Comments on Centredale Proposed Plan

Comments to the USEPA

Proposed Plan for the Centredale Manor Restoration Project

February 2012

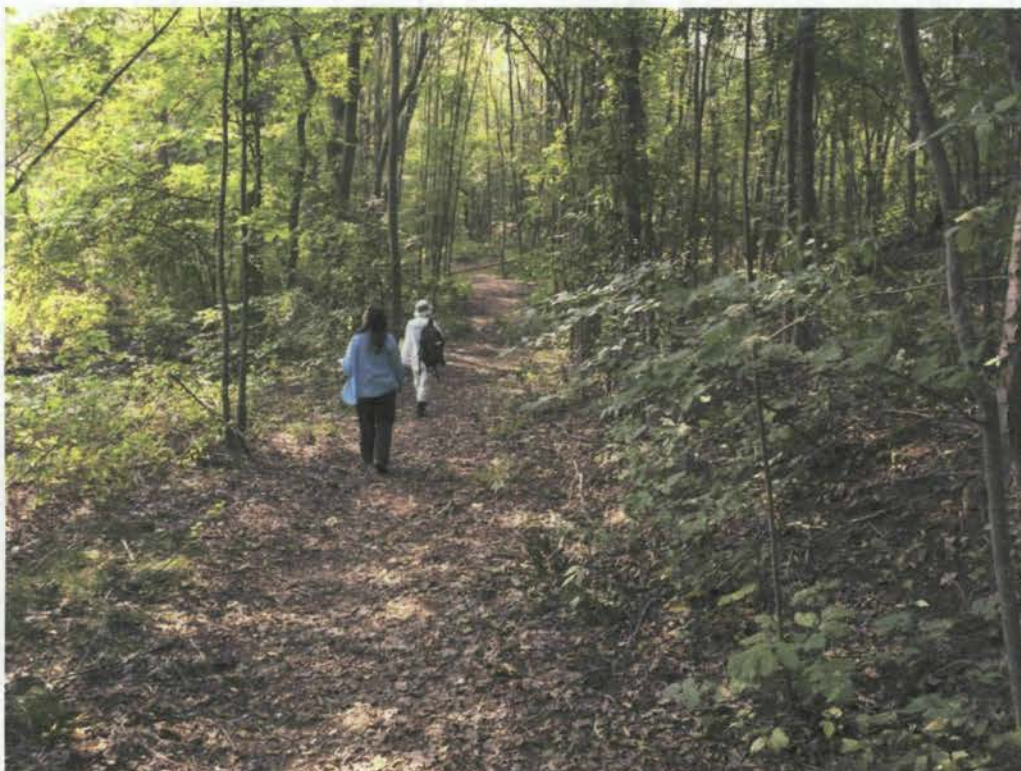
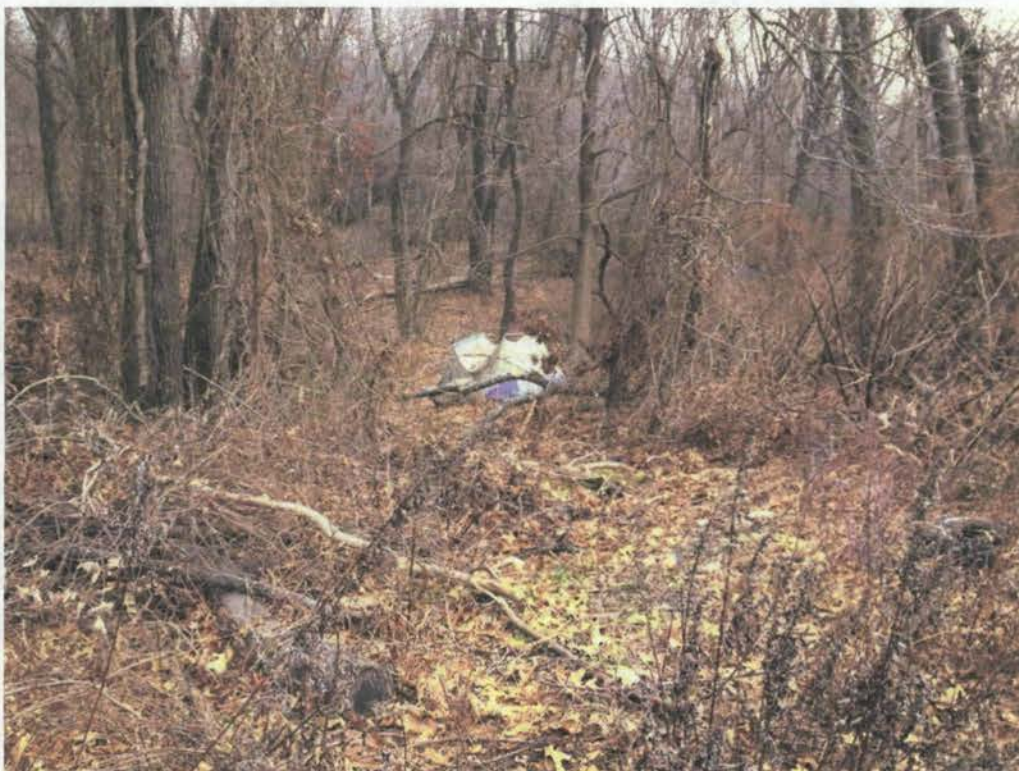
- f. While we are pleased to learn that the USEPA intends to use the RIDEM Direct Exposure Criteria as the soil remedial objective for the Oxbow, however we are concerned about the USEPA’s understanding of the human activities in the Oxbow. The USEPA’s information appears to be limited to observations of surface litter/debris and surface water elevation. We suspect that USEPA’s understanding of the current human activities in the Oxbow may be inaccurate and that the USEPA’s use of the river’s flood plain may not be appropriate as a consideration regarding the areas where people are most likely to congregate. We have consistently observed a greater level of youth activity in the Oxbow during the summer, when the river levels are at their lowest and the Oxbow at its driest. During our visits to the Oxbow we have observed evidence of: youths using the area as a gathering place, fishing, hunting, camping and all-terrain vehicle use. Please refer to the attached photos (1 through 5) which depict evidence of some of these activities.

Photo 6 – Water Collecting Behind Allendale Dam In Mill Sluiceway

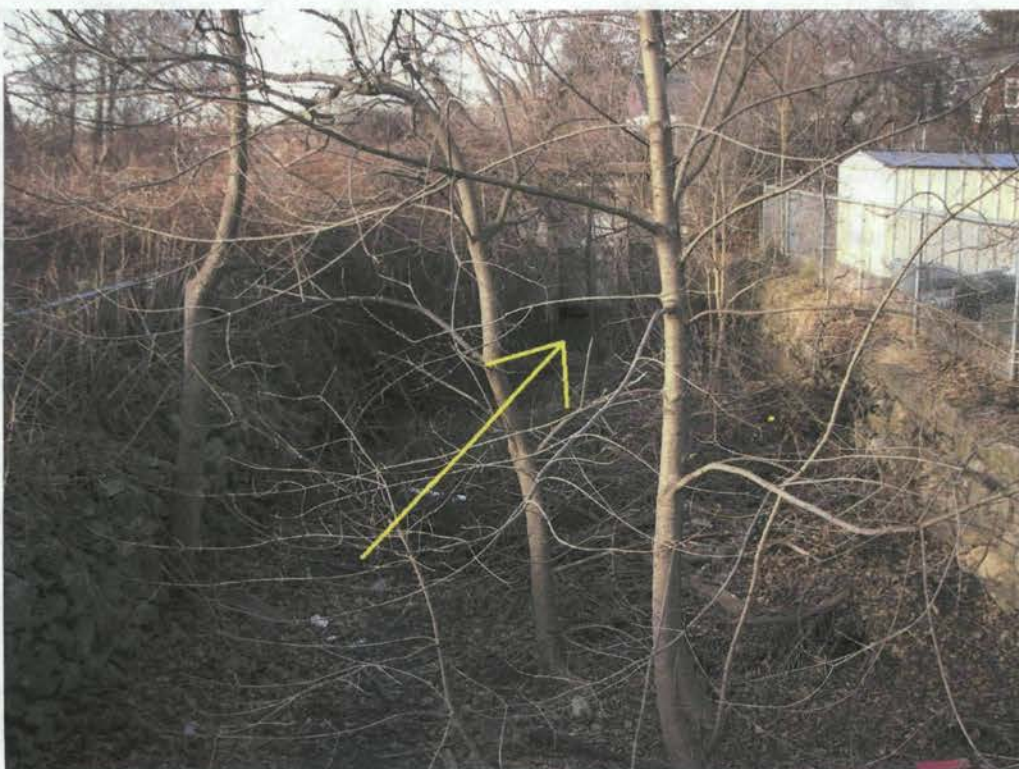
20. We suggest that after the removal of impacted sediment from the Allendale Mill sluiceway, that the portion of the sluiceway between Allendale Avenue and the Allendale Pond Dam be filled to surface grade and compacted with suitable material so as to avoid this channel becoming a potential source of floodwater into the Mill at Allendale condominiums. It is important to note that it is common to observe water ponding at the toe of the dam (see Photo 6).
